## ADDENDUM No. 2

**Project: 2024922**  
**South Jones High School Athletic Buildings**  
**Jones County School District**  
**Laurel, Mississippi**

The following additions, changes, clarifications, and substitutions to the drawings and specifications, dated June 25, 2025, are to be included as part of the contract documents. Acknowledge receipt of this addendum by inserting its number and date in the proposal form.

1  
A7.2 **SOCCER-VOLLEYBAL LOCKERS LAYOUT - BASE BID**  
SCALE: 1/4" = 1'-0"

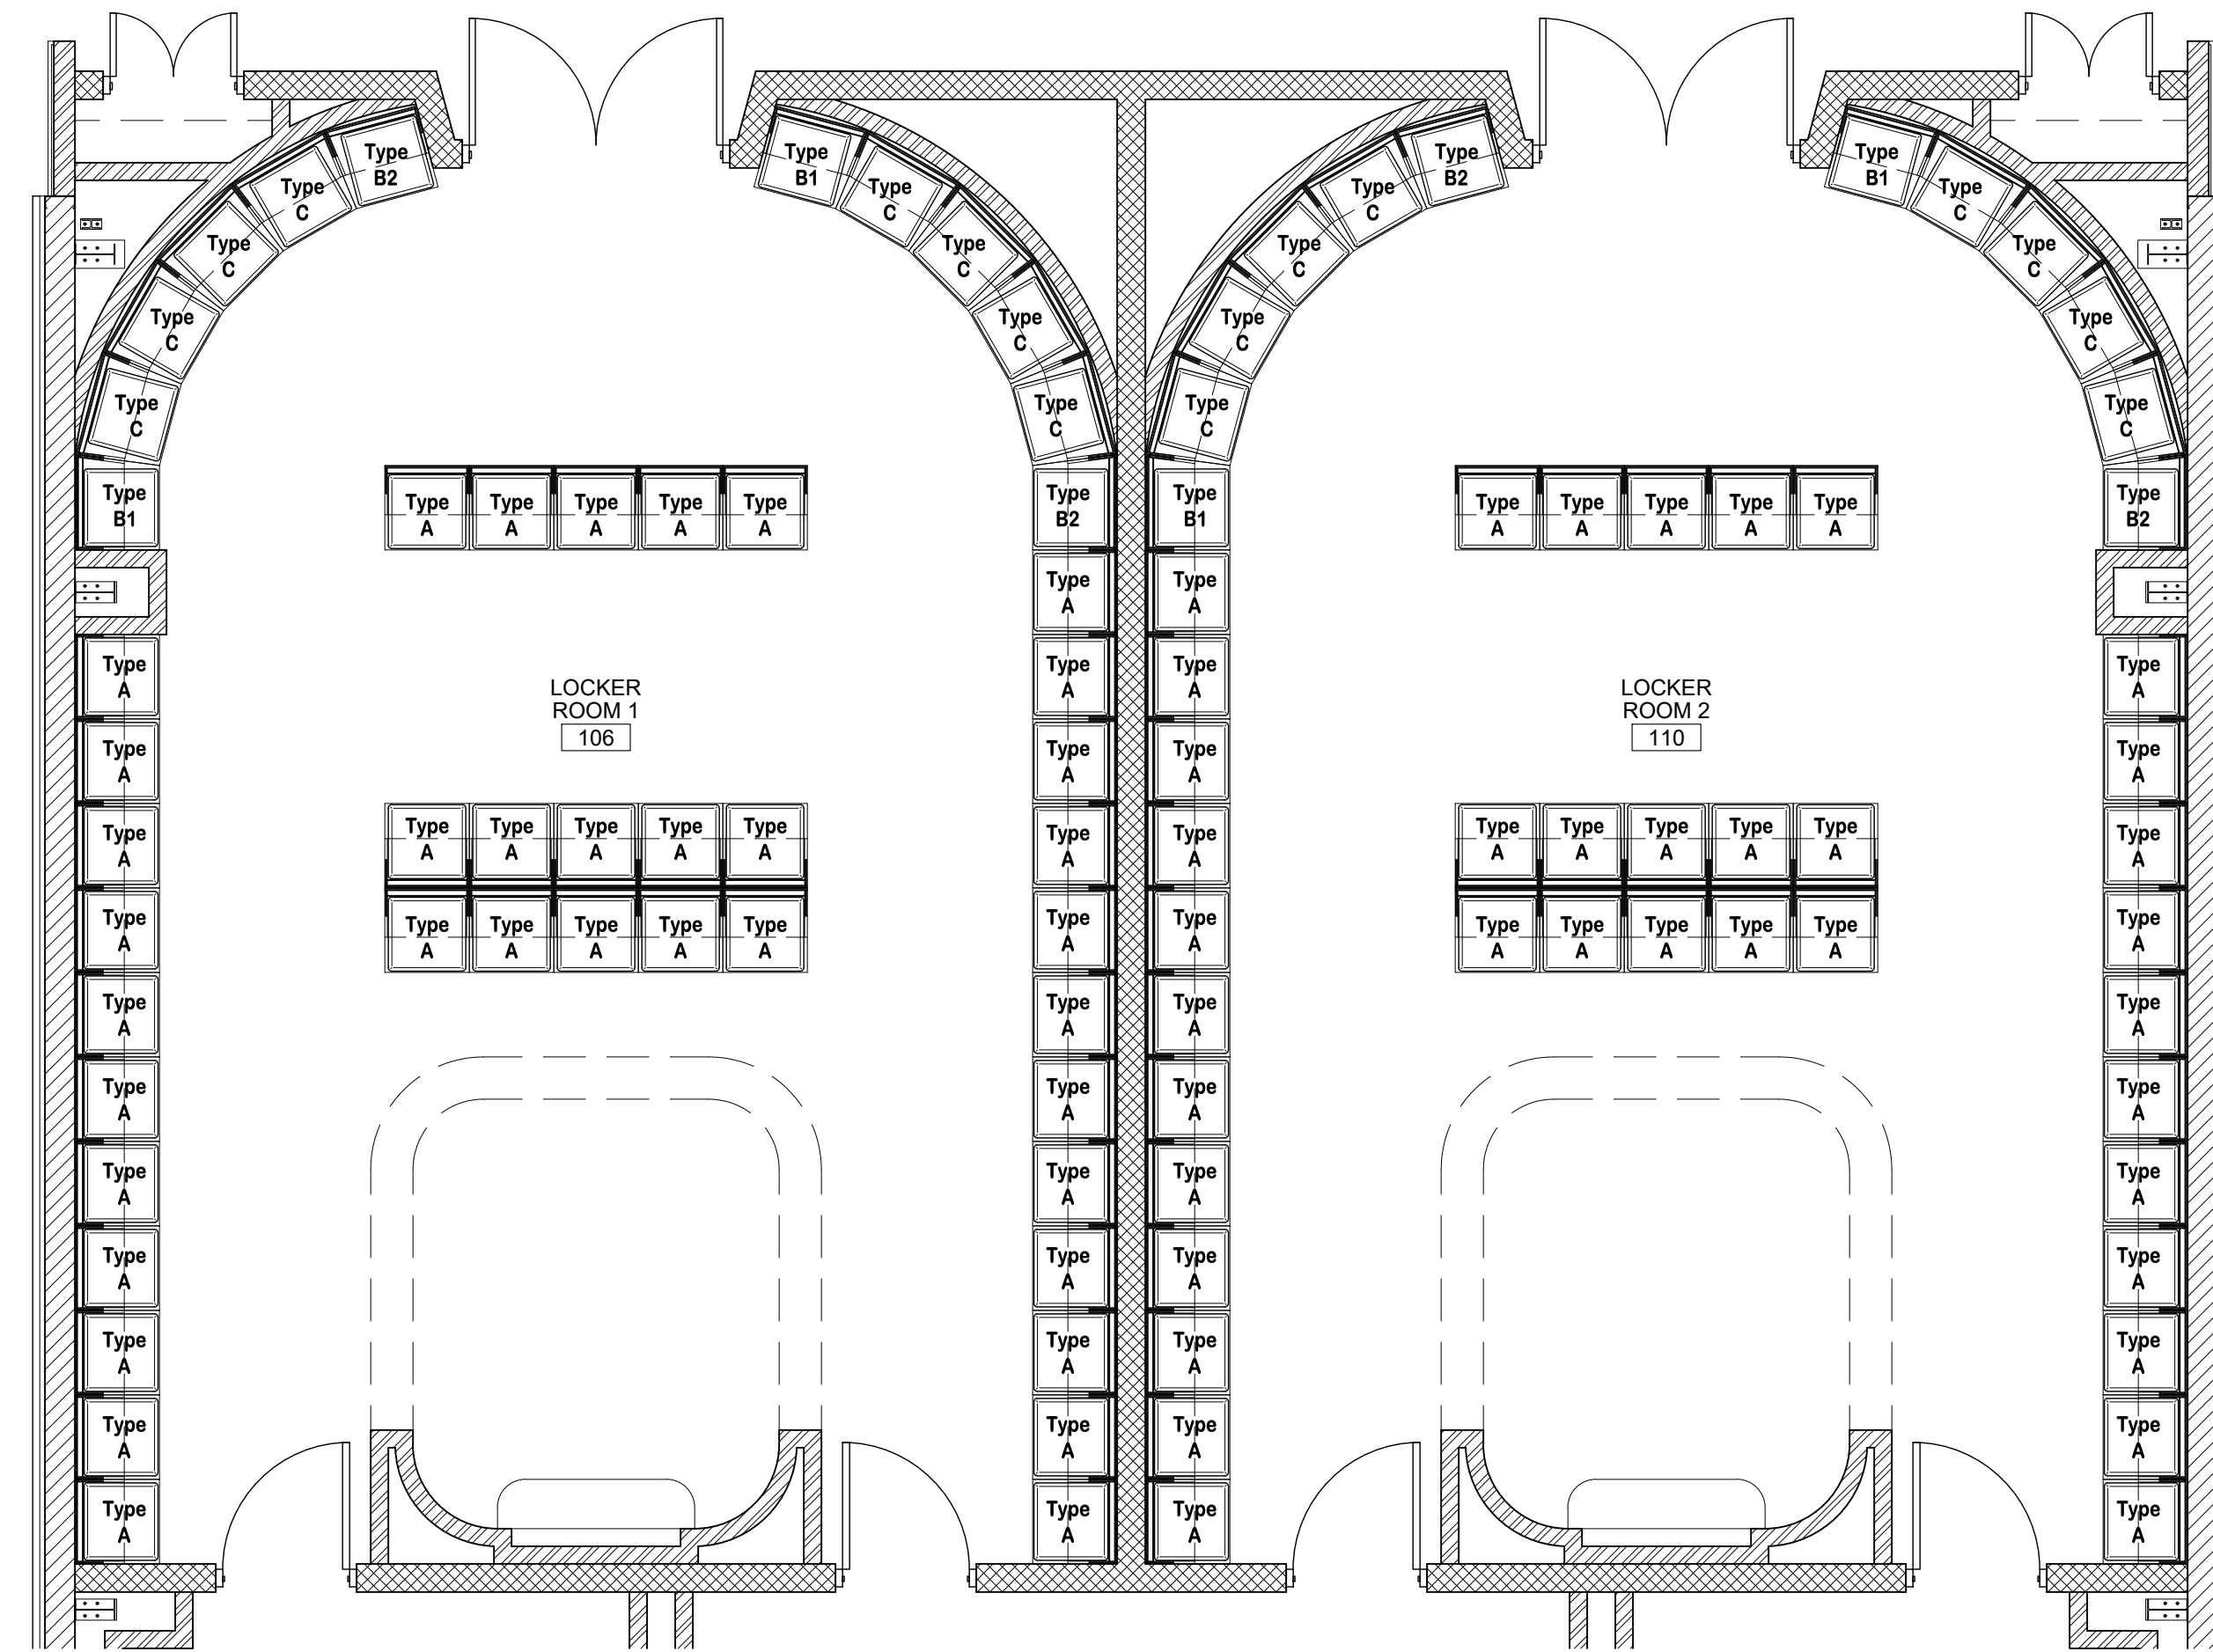
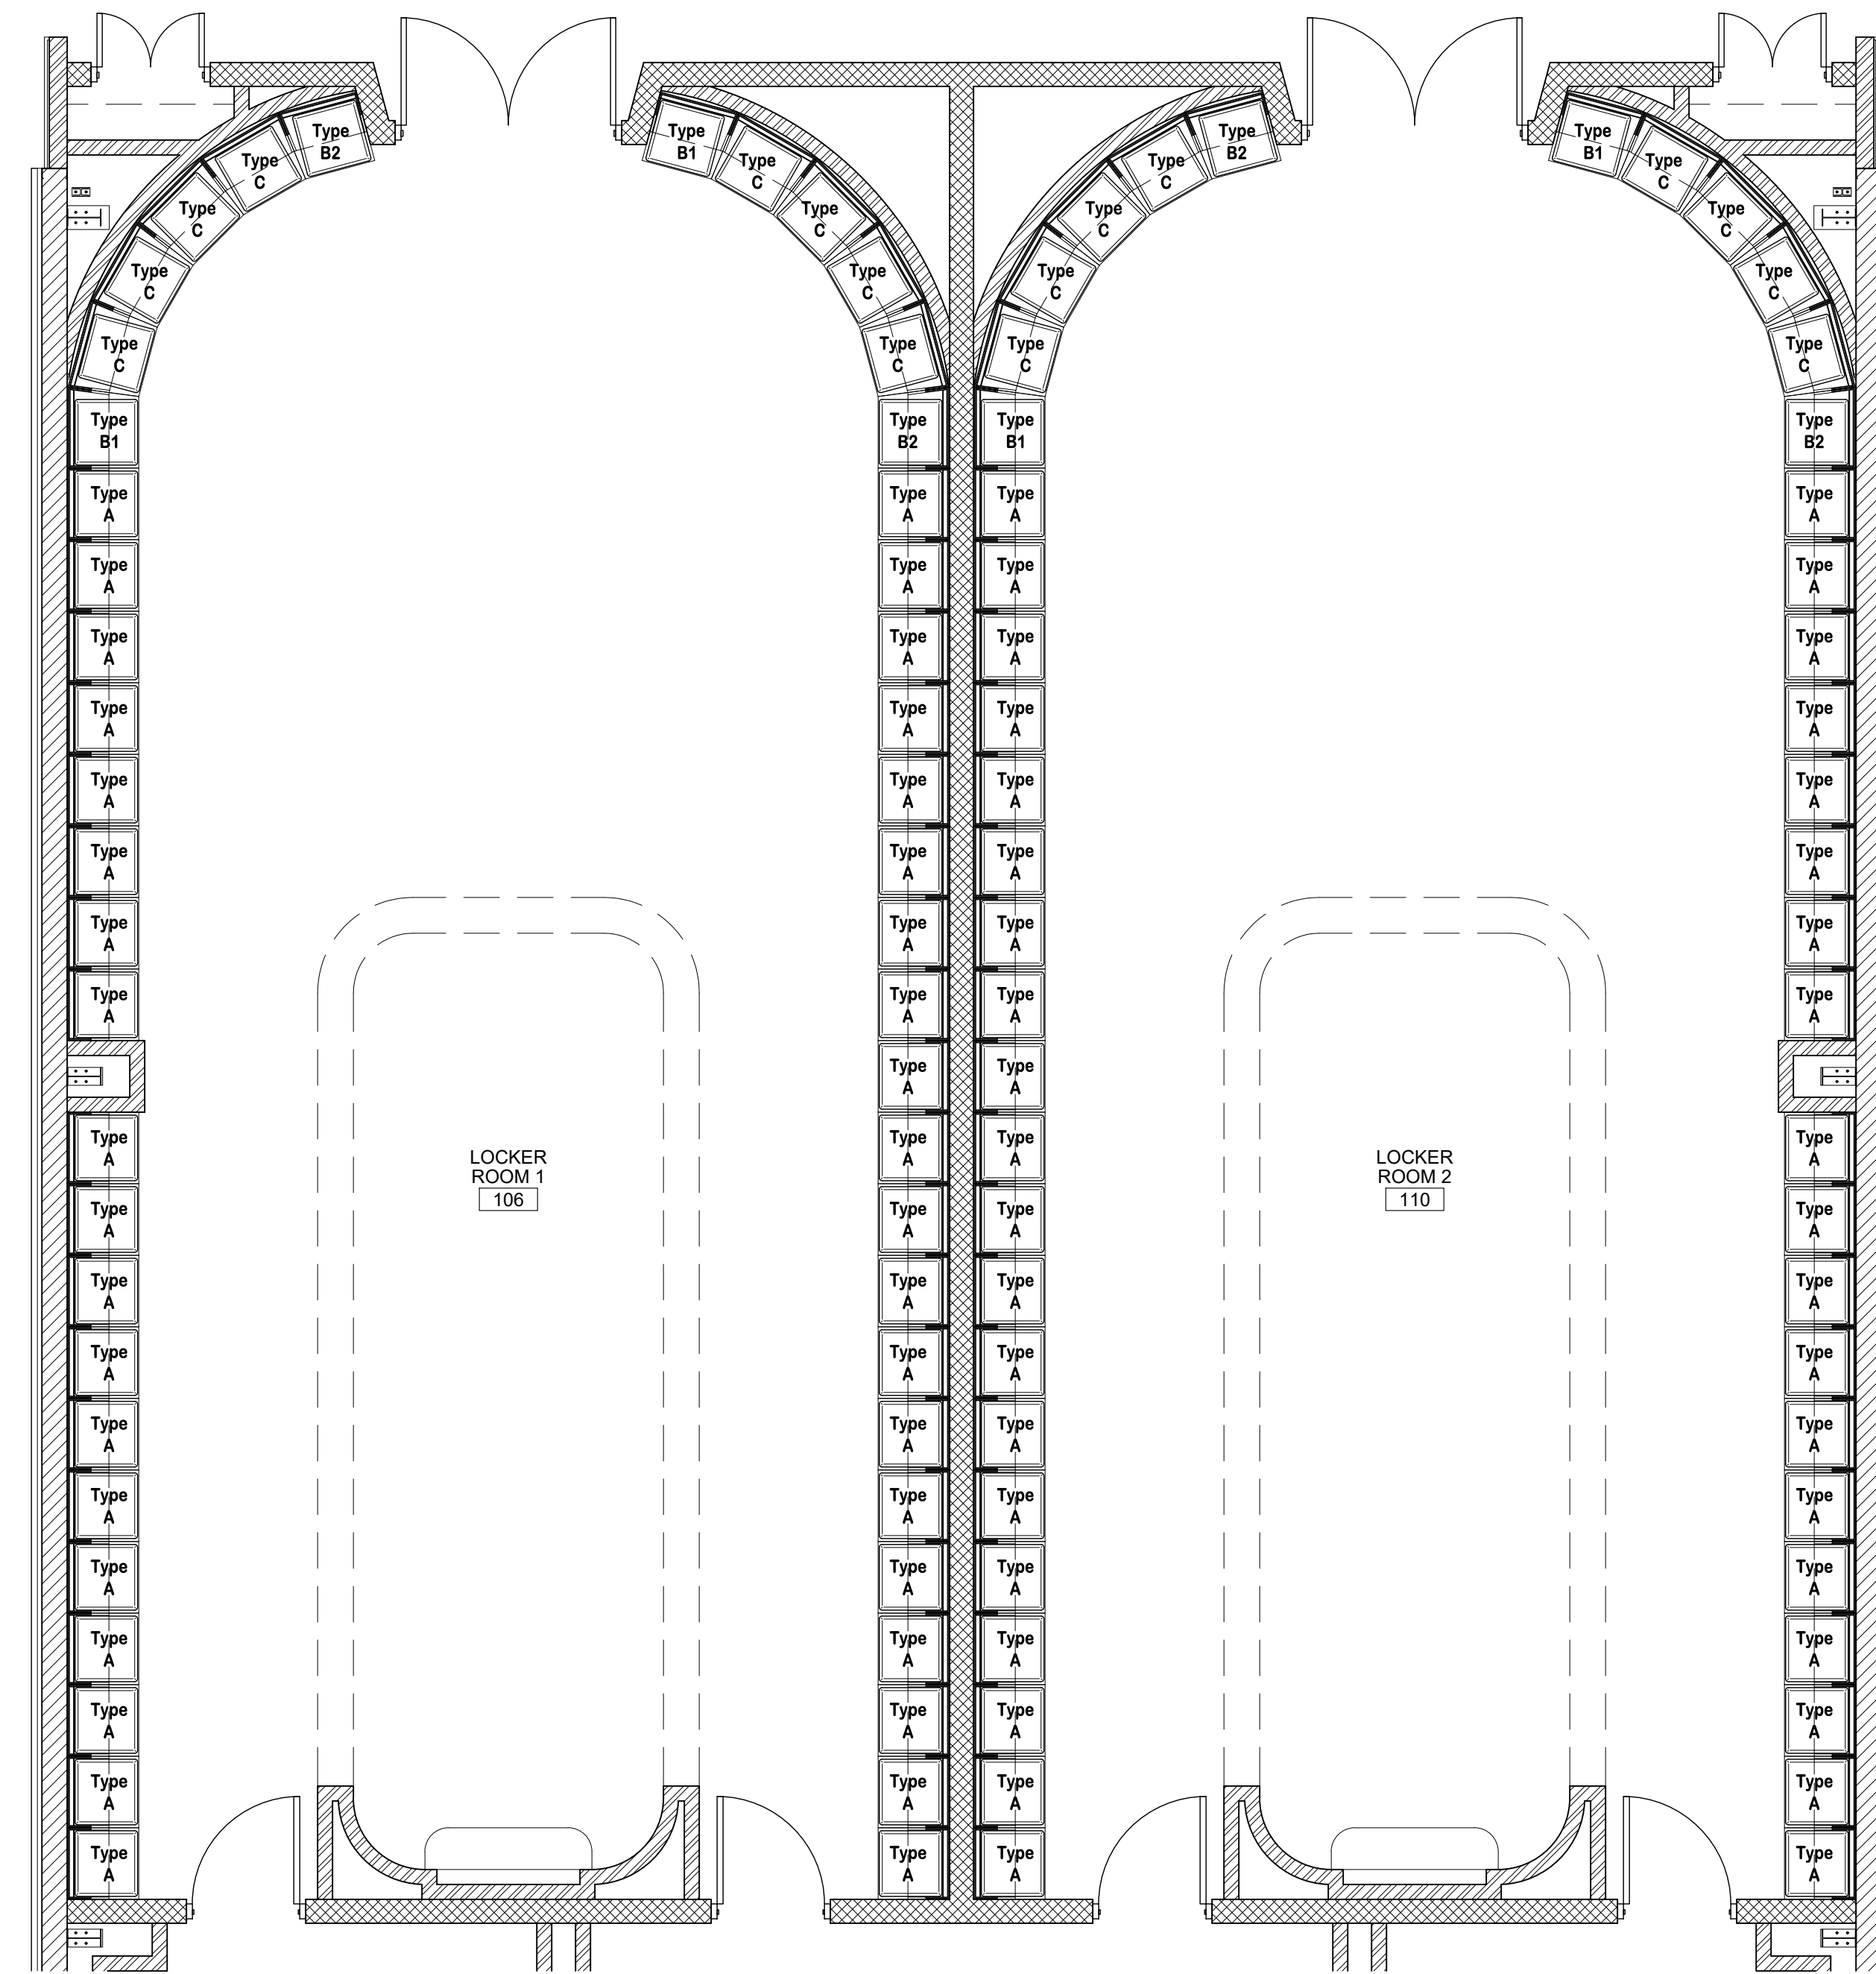
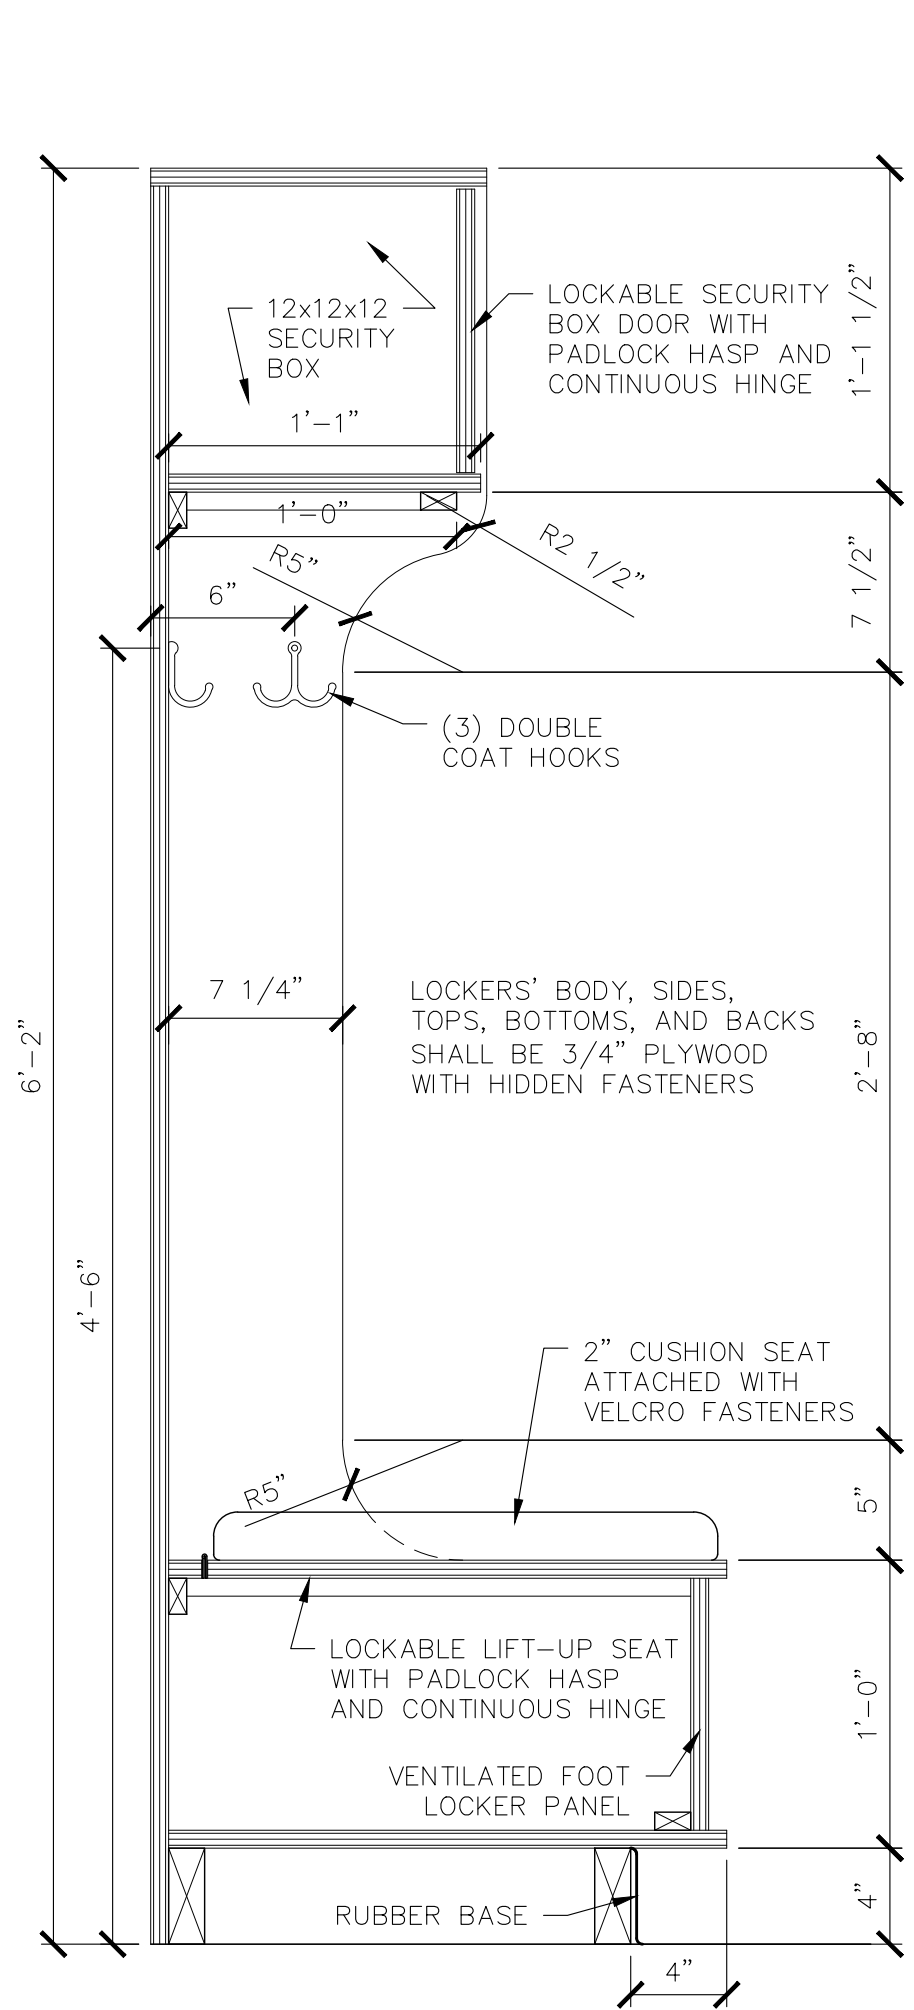
- Item No. 2. Refer to Project Manual – Add the enclosed Section 01 18 03 Project Utility Sources.
- Item No. 3. Refer to Project Manual – Add the enclosed Section 10 51 16 Athletic Wood Lockers. Athletic Wood Lockers shown on A7.1 and A7.2 shall be per enclosed Section 10 51 16 Athletic Wood Lockers.

- Item No. 26. Refer to Sheet A1.33, Plan 1/A1.33 and 2/A1.33, Note 5 – Refer to enclosed A7.2 for Lockers' Layout and Details.
- Item No. 27. Refer to Sheet A1.33, Plan 1/A1.33 and 2/A1.33, Note 6 – Coaches Lockers shall be Type A as shown on A7.2.
